# Clause 92 Host Board Transmission Line Model Parameters Adjustment

# SBR with package and host board added to 'Bugg 5m trace per table 92-13 D2.2 produces non-causal response.

# Proposed table change for table 92-13

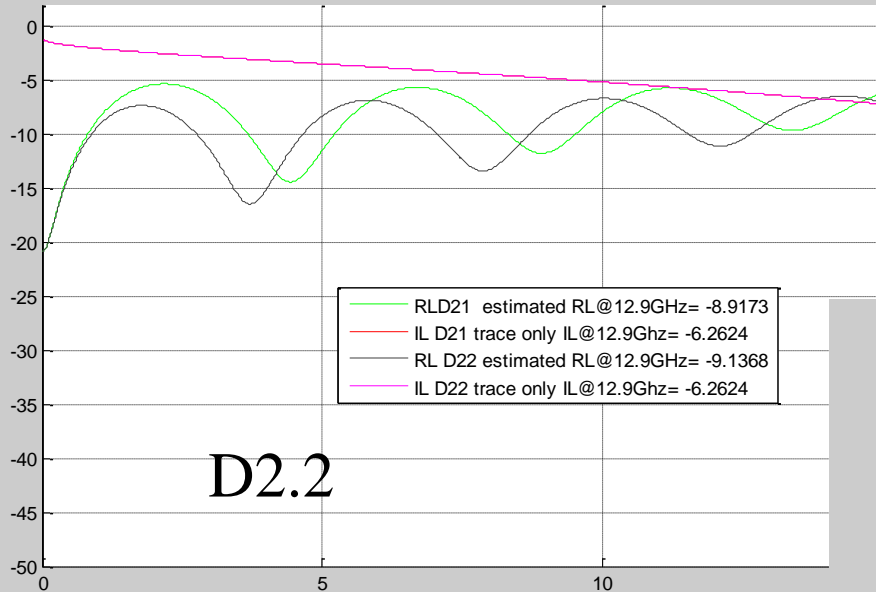
$\gamma_0$	-1.89E-04	0
$\gamma_1$	-1.93E-04	-9.75E-04
$\gamma_2$	-2.96E-04	-3.79E-02
$\gamma_4$	-2.47E-06	8.89E-06
$\rho_0$	5.11E-04	0
$\rho_1$	3.07E-18	3.40E-03
$\rho_2$	1.33E-04	1.09E-18
$\rho_3$	-4.71E-21	-3.02E-06
$\rho_4$	-6.80E-08	-2.63E-21

z_bp (TX)	141
z_bp (NEXT)	68
z_bp (FEXT)	68
z_bp (RX)	141

This was a transcription typo as these values were copied from simulations performed in the wee hours at May'12 Plenary  
But even with the correction there may be too much loss at DC and non causality

- Accept parameters in presentation for table 92-13
- Add a line in clause 93A.1.2.4 and 92.10.7.1.1 suggesting a limitation of 40 GHz bandwidth or the application of the receiver filter. Editorial license granted.

# Just about the same 6.26dB loss but RL and DC loss are different

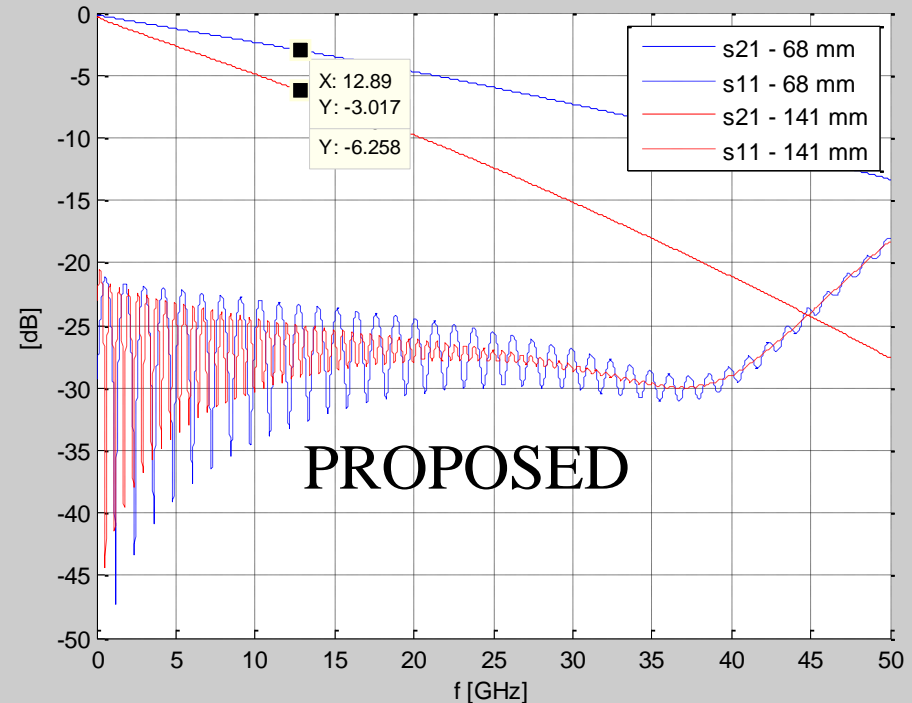
Host board loss for 185 mm trac length

This model requires the receiver filter to be applied prior to transforming into the time domain.
